ALKI BEACH RESIDENCES

CITY OF SEATTLE DESIGN REVIEW

EARLY DESIGN GUIDANCE MEETING #3
DPD PROJECT #3020640
MAY 4, 2017

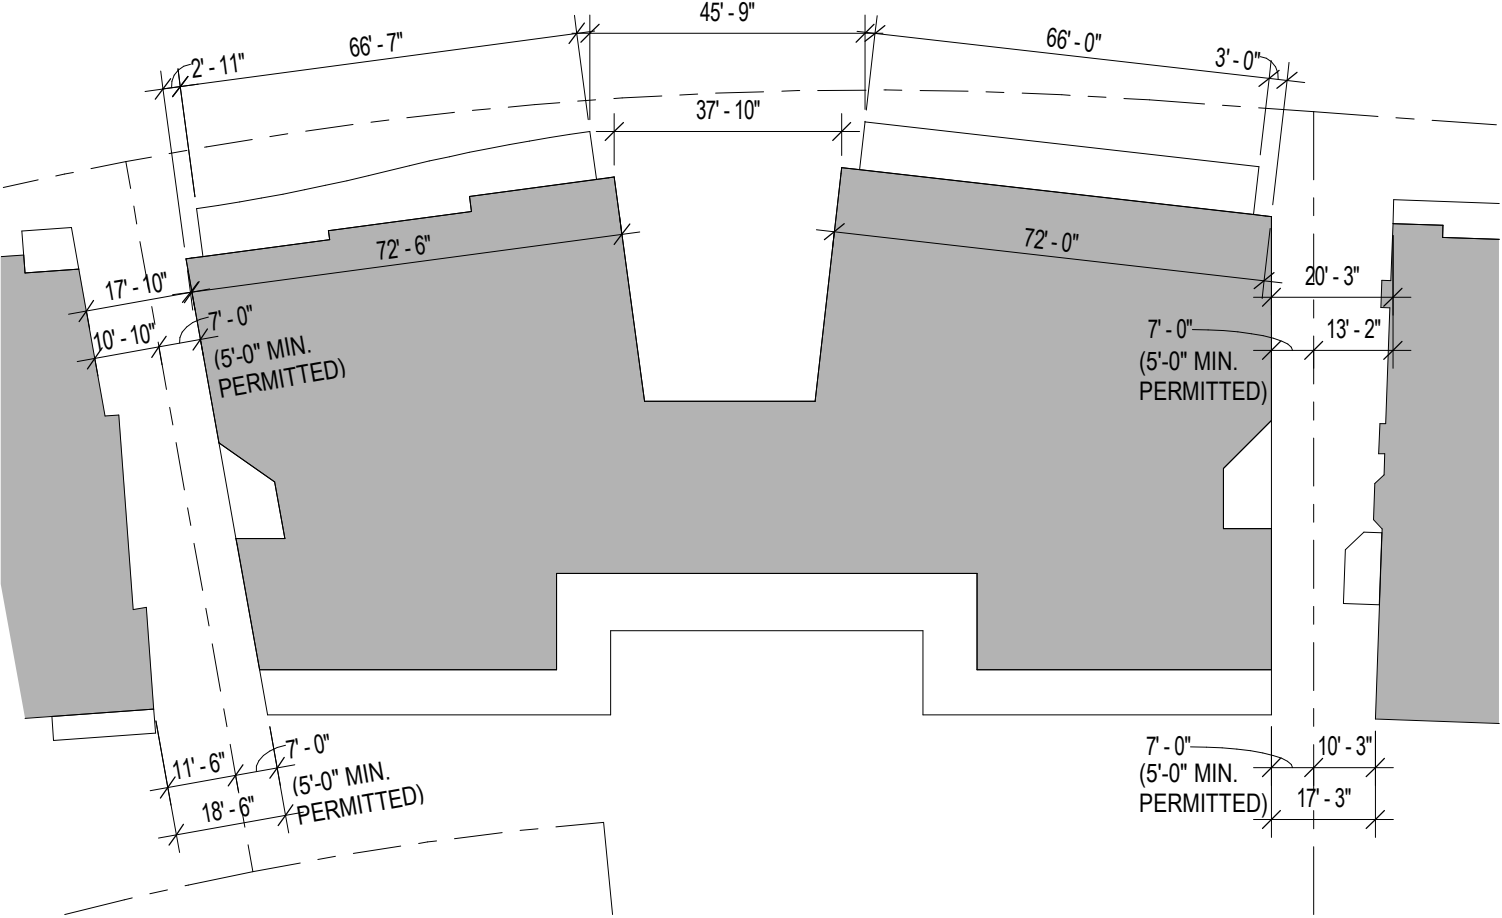
CONCERN #1

Response: The Design Review Board requested that the courtyard width be maintained to break down the perceived length of the building and provide greater separation between the two masses. The Board also suggested maintaining the structure width departures, however our team is now presenting a very different and much improved program that better aligns with the Alki Beach community. In developing thoughtful and successful residences along Alki, it is important to maximize the building frontage with views to the water and beyond in line with what is permitted by code and the intent of the zoning code. We understand concerns from the adjacent neighbors and have carefully studied the floor plans of the neighboring units. The adjacent units to the east and west extend the full length of the building therefore views to the water are still intact facing Alki. The MR zone supports higher density and the zoning code allows a minimum 5' side yard setback (7' average), however we want to maintain as much width as feasibly possible between the structures. Rather than maximizing the width facing Alki, we have elected to provide the 7' setback along the full length of the structure.

In reviewing the neighboring structure to the east, we have also learned that the overall width of the building is 69'. The proposed masses along Alki are 72'-6" and 72' - only 3 to 3'-6" additional feet wider than the neighboring structure. When added together, this dimension is still less than the maximum 150' width permitted by the zoning code. The large, deep and open balconies have been further inset at the sides, therefore the perceived mass is further reduced.

Approved EDG2
East alignment diagram

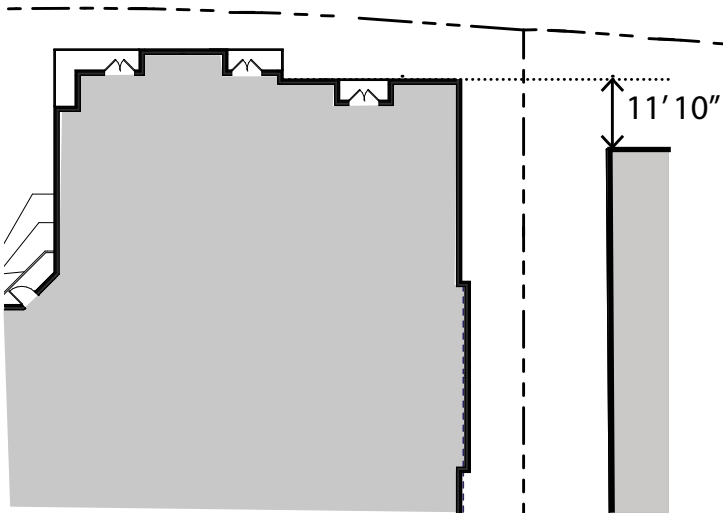
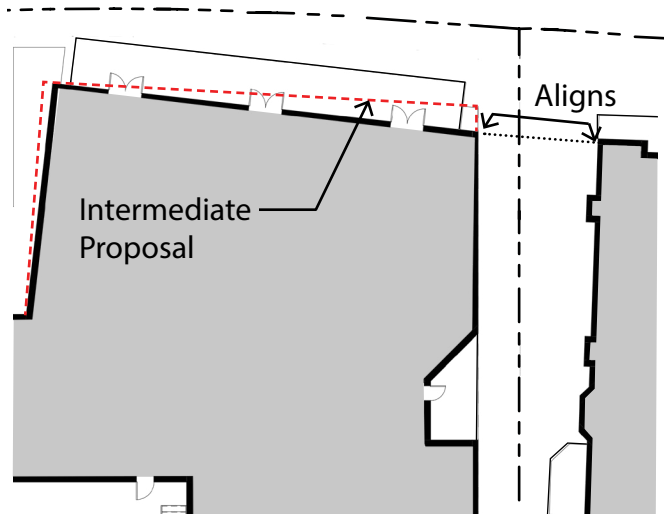
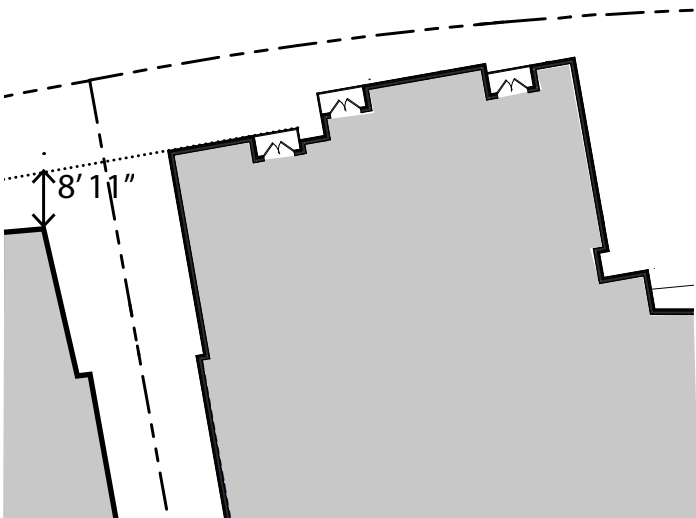
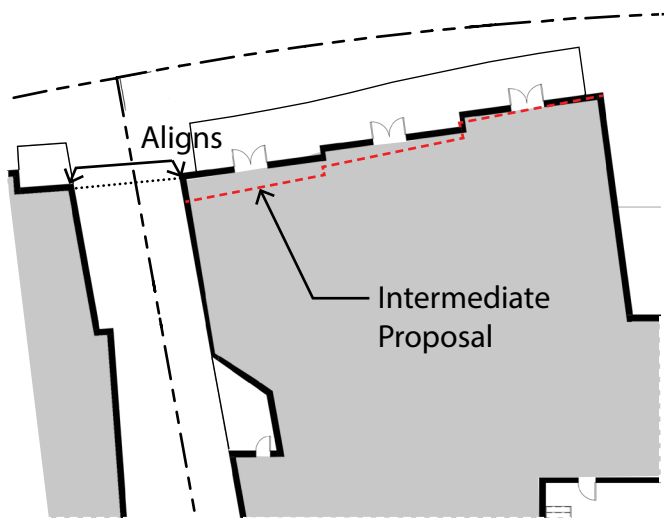
The structure does not align with the neighboring structures at the upper levels (levels 2-6) .

Response: An intermediate proposal had aligned the building with the curvature of Alki Avenue. In working with the AAA Board, we have revised the design to re-orient the building to better align with the neighboring structures. This increases the front yard setback by approximately 12’ on the east side and approximately 9’ on the west side in comparison to the approved design from the second EDG meeting.

Ground Level Plan Dated 03/24/17

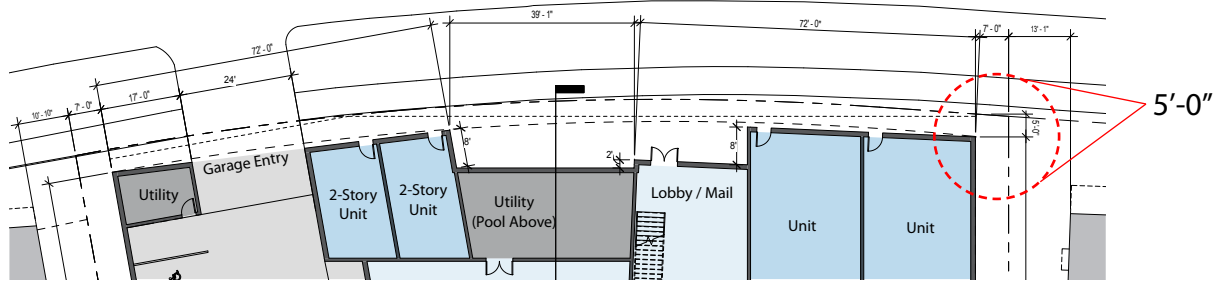
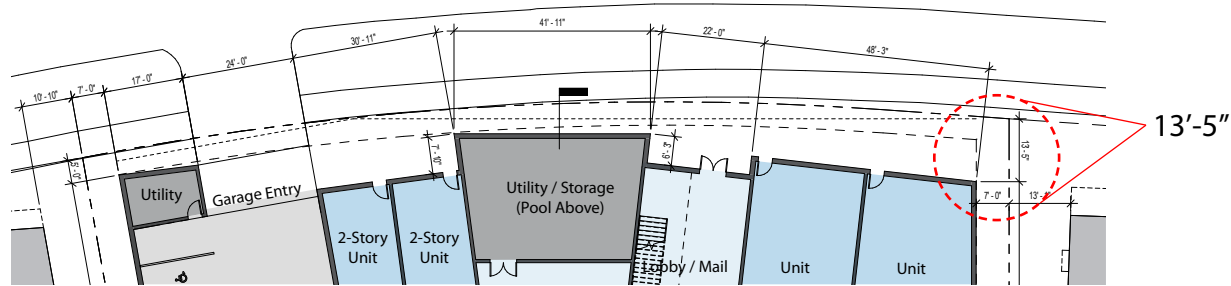
CONCERN #3

Response: The design team has revised the ground level footprint to set back further from the sidewalk.

An intermediate proposal had looked at pushing units out towards the sidewalk while setting the infinity pool back.

In the current proposal, the units are set back to provide a landscaped terrace entry to each unit while pulling the infinity pool out strengthening the visual connection to the water. The waterfall effect of the infinity pool will create a calming natural element along bustling Alki Avenue. This adjustment provides a buffer to the units while expressing the water feature as a focal point.
